Supplementary Landscape Assessment Memo

Proposed Ayrburn Screen Hub
1 Ayr Avenue, Arrowtown

9 January 2026

This Supplementary Assessment Memo relates to matters raised in the Ayrburn Screen Hub - Landscape Peer Review prepared for Queenstown Lakes District Council by Bridget Gilbert, dated 4 December 2025 - (FTAA-2508-1093). This memo also comments on matters raised in the evidence of Rebecca Hadley, as directed by the Panel. This memo also responds to comments of Jan Andersson¹, and the comments of Greg and Lianne Collins² which raise concerns about the effects on views from their properties. I have structured my memo by responding to Ms Gilbert's comments first, followed by my response to Rebecca Hadley and then I address the effects on those neighbours. I draw the Panel's attention to the fact that a number of my responses to Ms Gilbert's report, can be taken as addressing the same concerns raised in the Hadley, Andersson and Collins comments.

Figure 1. Masterplan with Ayrburn Structure Plan Overlaid

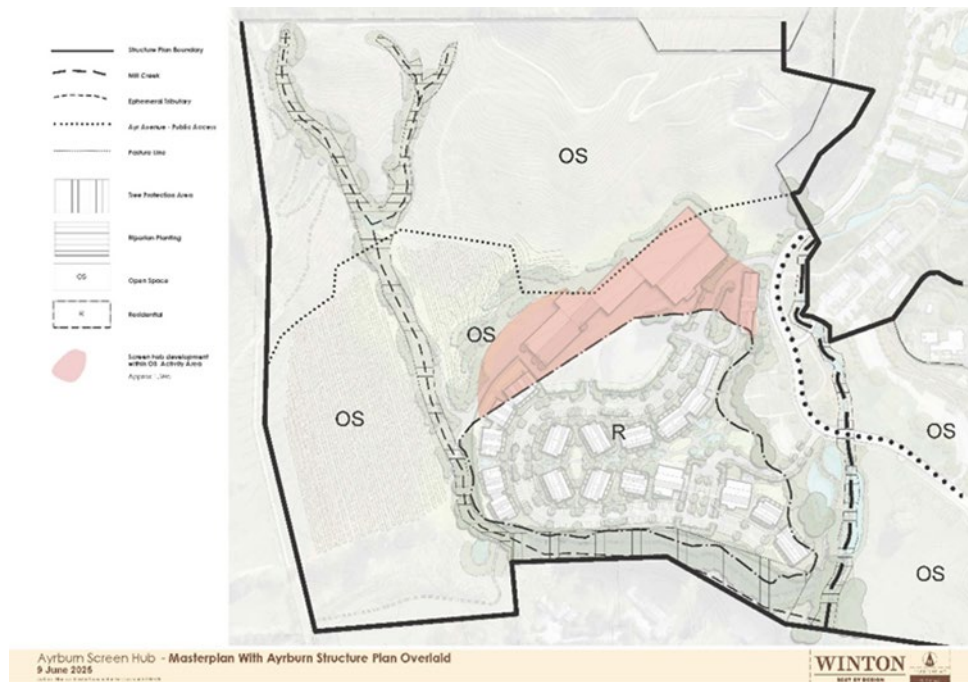
When one ‘steps back’⁵ and considers the continuous spatial patterning of the land to both the east and west, I acknowledge that there will be a relatively small loss of spaciousness, openness and ruralness, but cannot see how such a small (in terms of area) intrusion into the OS will adversely affect these sensory elements, and the ‘spatial approach articulated in the District Plan, both at a landscape unit and Ayrburn Structure Plan scale’, to the extent claimed by Ms Gilbert.

It is my understanding that the OS area as shown on the ASP is intended to provide an appropriate interface between development in the ASP and adjacent zones - particularly the Millbrook Resort Zone (MRZ) and the Waterfall Park Zone (WPZ). In my opinion this is retained in a meaningful way and does not erode the deliberate spatial approach as per the PDP provisions.

Figure 2: Figure 1 - Appendix 20 Proposed Contour Overlay Plan (red linework) overlaid on Existing Contours (black linework) from the Landscape Peer Review.

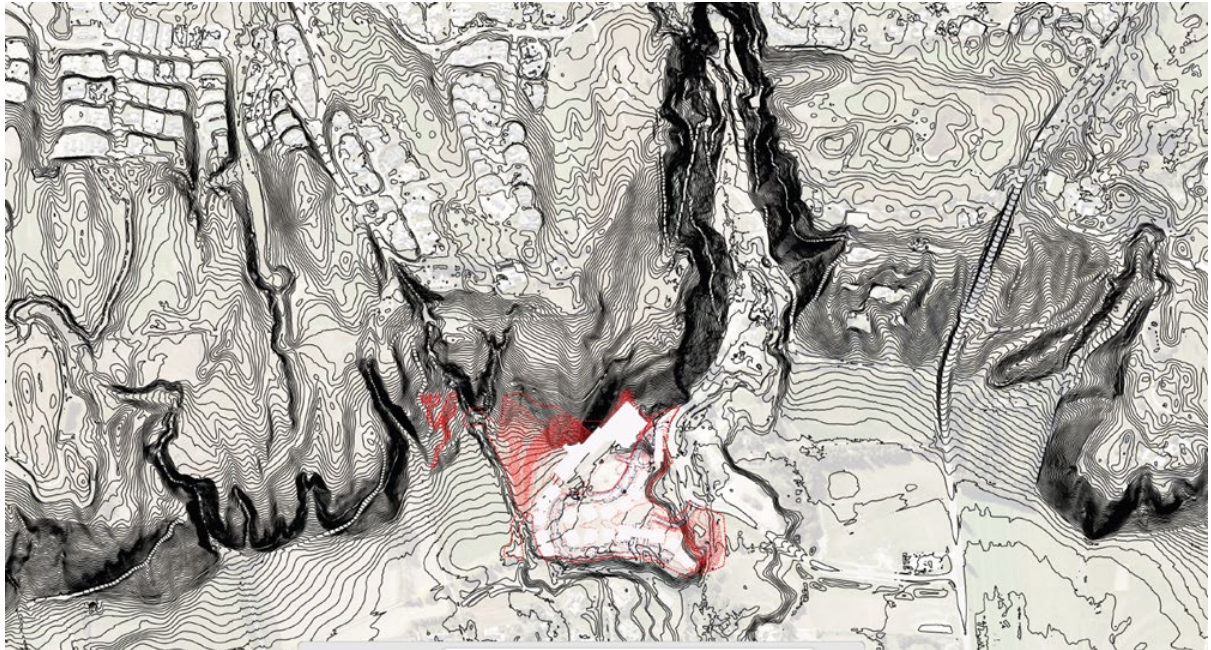
In response to Ms Gilbert's comments at [5.25 – 5.29] regarding the proposed spur, it is my experience through involvement in several infrastructure projects over the years that a bund is often a 'standalone landform' and typically regular (and somewhat sausage like) in both width and height. In my opinion that is quite different to both a mound and a spur extension, as is the case with the proposed landform. Given the fact the proposed landform varies in both width and height across its length, and extends from a sub spur of, and at the toe of Christines Hill it will mimic an extended natural spur landform and will not be incongruous within the wider landscape setting.

In my opinion Figure One (as shown as Figure 2 below) within Ms Gilbert's report demonstrates the small scale of the spur extension in the context of the continuous sequence of escarpment slopes of the Wharehuanui Hills landform that define the edge of the Speargrass Flats alluvial valley floor.

At the broader Speargrass Flats scale, due to the small and contained scale of the spur extension, the legibility and expressiveness values associated with the Wharehuanui Hills landform are maintained.

Figure 4 – Location of the Andersson Property showing Viewpoint Locations used for Visual Modelling

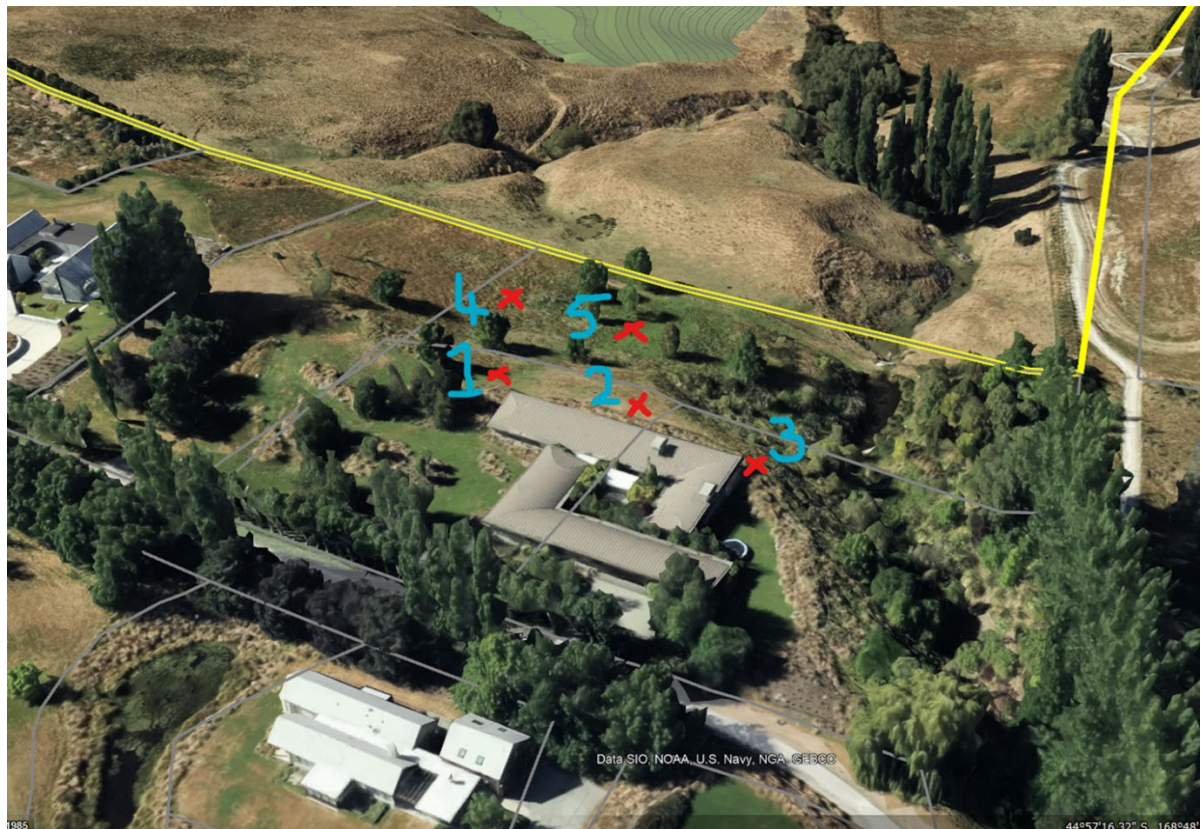
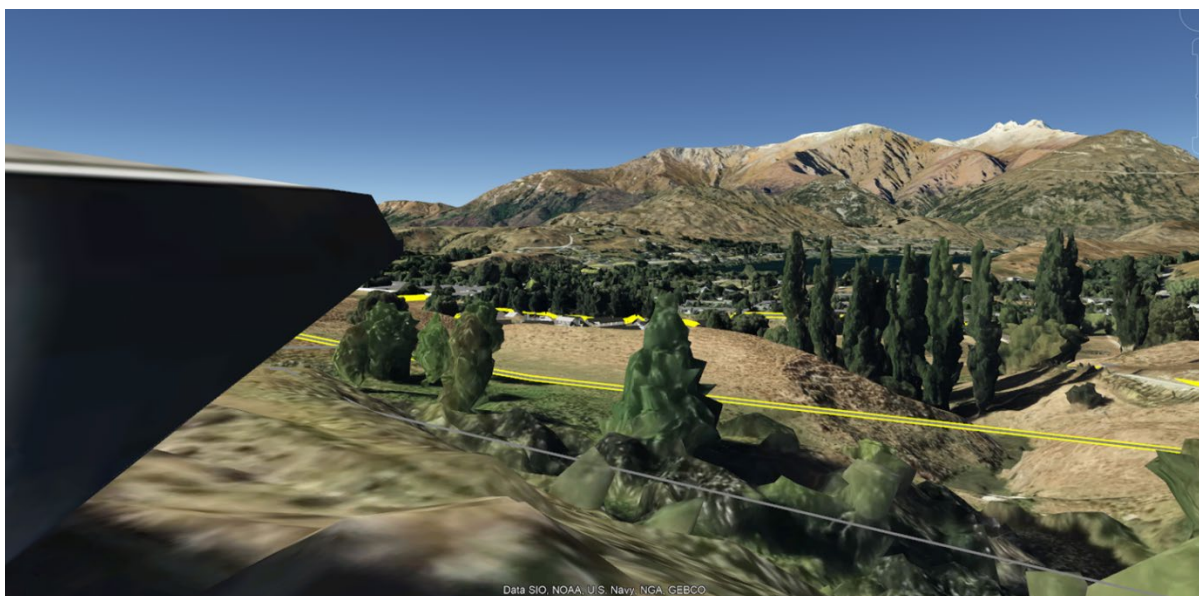
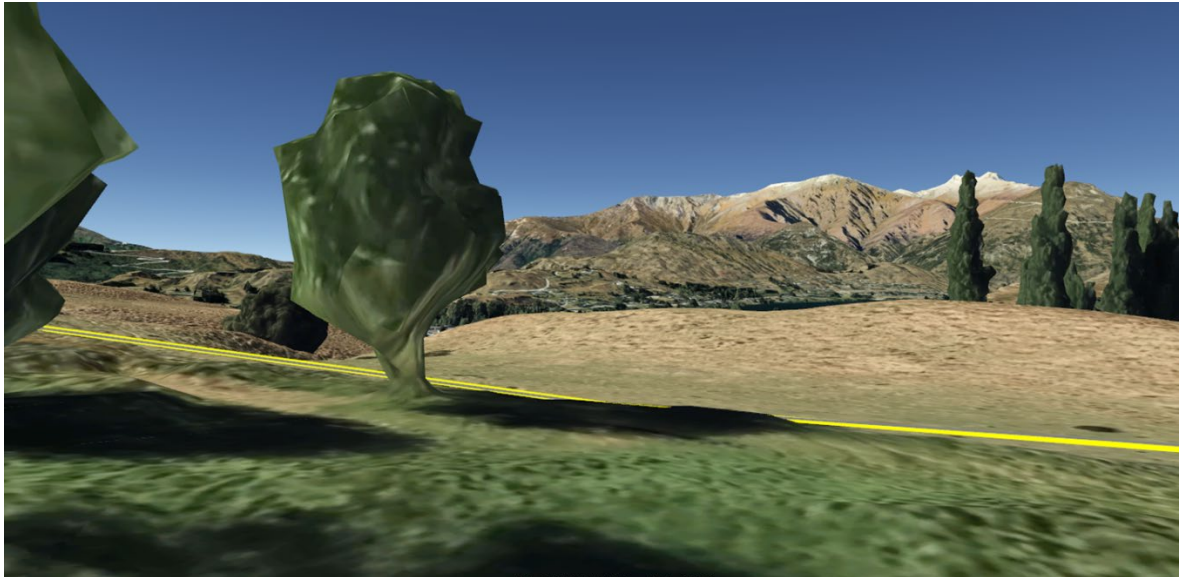
In reviewing the evidence of Jan Andersson, I understand the panoramic view described at [16]. However, it would have been helpful if the evidence included photographs that graphically verified the written description provided. So as to understand the full impact, visual modelling has been undertaken for the proposal in order to verify the claims²⁰ being made in regard to the visual impact and loss of rural outlook from the Andersson property at [REDACTED]. Given the timeframe between evidence and comments received and the writing of this supplementary memo, a further site visit has not been undertaken. However, having visited the Site many times, I am familiar with the boundary interface conditions and generally familiar with the outlook from 3 Millvista Lane.

Five views were modelled and overlain in a Google Earth model, see Figures 4 - 9 following that show snips from the modelling. The Google Earth model used includes the proposed spur extension which can be seen in Viewpoints 1 and 4. It does not include any of the planting associated with the proposal.

The double yellow line in the modelling depicts the boundary of the Site, while the yellow coloured 'dashes' identify the accommodation units (which have been modelled) that will initially be visible from the submitter's property. Notably, due to existing landform, the studio buildings will not be visible at all from these Viewpoints (which are representative of views from [REDACTED]). Regarding the accommodation units, as the mitigation planting grows on the proposed spur extension, these will be screened in time.

In my opinion Mr Andersson overstates the visual impact and loss of rural outlook when he claims ...*'In particular, two massive sound stage buildings (studios) are planned in the paddock directly west of my house'...* and ...*'From my property, these structures will be clearly visible. Today I see pastoral green fields. In the future I'd be looking at industrial sized buildings'*²¹. Then at [19] Mr Andersson claims...*'I anticipate that the pleasant rural vista I currently enjoy will be fundamentally altered and will feel more like looking over a town or large facility'*²².

This is for two reasons. First, the visual modelling shows that while some of the accommodation units will be initially seen, the studio buildings will not be seen from the Andersson property. Therefore, acknowledging the accommodation buildings will appear more urban than rural, *'industrial sized buildings'* will not be part of the view from the Anderssen property. Second, the current outlook from the Andersson property includes the RRA of the ASP, the area within which the accommodation units are proposed. While there is a consenting process to be followed, this area of the Site is identified for rural residential living, which will in itself provide a different outlook than currently experienced from the Andersson property.

Furthermore, the Site represents a very small part of the overall scene as appreciated from the submitter's property, the uninterrupted views across the Wakatipu Basin that take in Lake Hayes, Bendemeer, Morven Hill and The Remarkables remain. From the Andersson property the scale of proposal would be subservient to the wider landscape setting, and the existing spacious and open outlook in the available views will be maintained. Subsequently, *'scenic rural views'*²³ will also be maintained.

Figure 10 – Existing Character Plan – Site and Surrounds

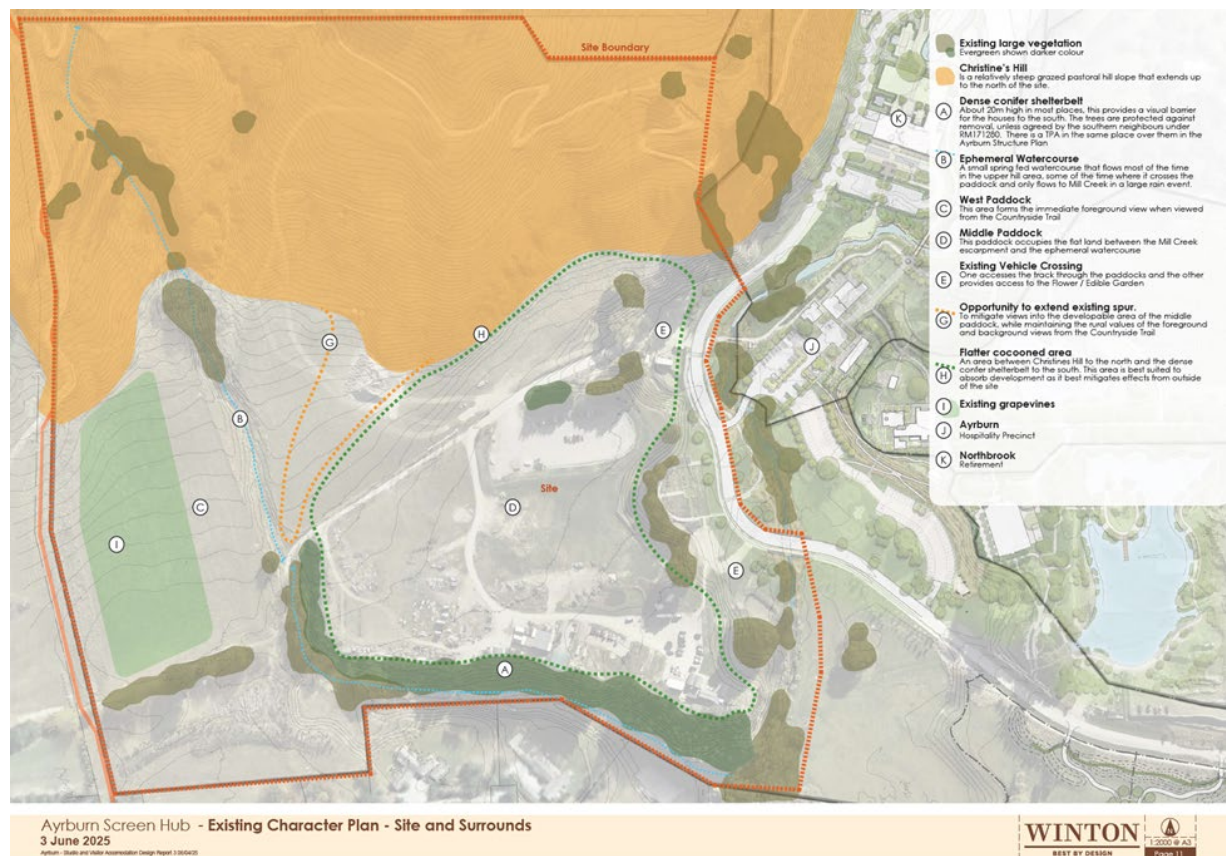
Regarding the Collins comments, I have reviewed the photographs²⁴ and written comments provided. It would have been useful to understand where exactly the photographs have been taken from, to verify the claim that... 'The proposed development would be clearly visible from our backyard, rear deck, main living areas, and multiple bedrooms.'²⁵

While I have not visited the Collins property at [REDACTED], I have previously walked and photographed the public bike and walking track along this southern edge of Ayrburn and adjacent to the Collins property. In this regard I make the following comments. The conifer shelterbelt identified as 'A' in Figure 10 below, is protected against removal, unless agreed by the southern neighbours under RM171280.

There is also a Tree Protection Area (TPA) in the same place over them in the ASP. In places the conifers are approximately 25m in height, and where there are gaps (as shown in the Collins' photographs) additional conifers have been planted over the last 12 months. While these conifers form a visual barrier and will increasingly do so when the recently planted ones grow, the overall amenity provided by them is relatively poor. The reason for this is threefold. In places they appear unkept, they cast considerable shade and they prevent longer views to the mountainous backdrop.

It is now my understanding that the proposal, subject to each relevant neighbour's sign off, is to progressively remove the conifers and replace them with a comprehensive planting of native species. This is primarily in response to matters raised in some of the comments in regard to the exiting conifers and the lack of quality of the southern boundary interface of the Site. Associated with this proposed planting would be an acoustic barrier (hedged on both sides so not to be visible).

It is also my understanding this would only happen if the relevant neighbour signs off / requests it for their relative adjoining part of the TPA, and that the relevant adjoining neighbour will have access into the adjoining part of the TPA to top trees in order to maintain views.

As far as views to the north from these neighbouring properties are concerned, the current views are mostly screened by the mature conifers, and the neighbours have no control over that situation. The combination of conifer removal/native planting/access to top trees will give these neighbours full control over the extent of screening and the extent of views to the north.
